Access Compliance Report

Public Rights-of-Way

(Curb Ramps)

Intersection ID: 47754	Main Street: REBECCA_RUN_DR	Cross Street: BROCK_RN	Location:	N
ADA ID: C320FFE66595	Ramp Type: BlendTrans1	Initial Pass/Fail: Fail	Overall Compliance: No	Severity Score: 8.75

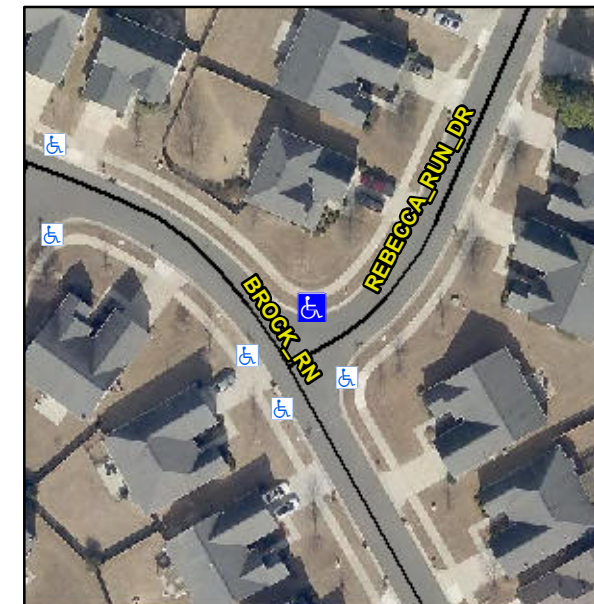
Not Found, R304.5.1

Compliance	Description	Data	Compliance	Description	Data
N/A	Ramp Length (in)	72.0	Yes	BlendTrans Slope (%)	3.5
No	Ramp Width (in)	37.0	Yes	BlendTrans XSlope (%)	0.0
N/A	Flare Type LT	N/A	N/A	Flare Type RT	N/A
N/A	Flare Slope LT (%)	N/A	N/A	Flare Slope RT (%)	N/A
N/A	Flare Traversable LT?	N/A	N/A	Flare Traversable RT?	N/A
N/A	Landing Length (in)	N/A	N/A	DWS Provided?	N/A
N/A	Landing Width (in)	N/A	N/A	DWS Contrast?	N/A
N/A	Landing Slope (%)	N/A	N/A	DWS Length (in)	N/A
N/A	Landing X Slope (%)	N/A	N/A	DWS Full Width?	N/A
N/A	Landing Curb? (Y/N)	N/A	N/A	DWS Offset (in)	N/A
N/A	Shared Landing?	N/A			
N/A	Gutter Ponding?	N/A	N/A	Gutter Slope (%)	N/A
N/A	Gutter Lip Ht (in)	N/A	N/A	Gutter X Slope (%)	N/A
N/A	Painted X Walk1?	No	N/A	Painted X Walk2?	No
	X Walk 1 Direction	To SW		X Walk 2 Direction	To SE
	X Walk 1 Width (in)	N/A		X Walk 2 Width (in)	N/A
	X Walk 1 Slope (%)	1.1		X Walk 2 Slope (%)	1.5
	X Walk 1 X Slope (%)	1.1		X Walk 2 X Slope (%)	3.9

N/A	Ramp inside XWalk1?	N/A	N/A	Ramp inside XWalk2?	N/A
	Road Slope (%)	1.0		Clear Space?	N/A
	Road X Slope (%)	4.2	N/A	Clear Space to XWalk (in)	N/A
N/A	Any Obstructions?	N/A	N/A	Storm Grate/Utility Hazard?	N/A
	Obstruction Type			Storm Grate/Utility Type	
		N/A			N/A
			Yes	Surface Condition? (G/P)	Good
			No	Curb Slope (%)	18.5

Remove & Replace Curb Ramp With Two New Directional Ramps or Equivalent.
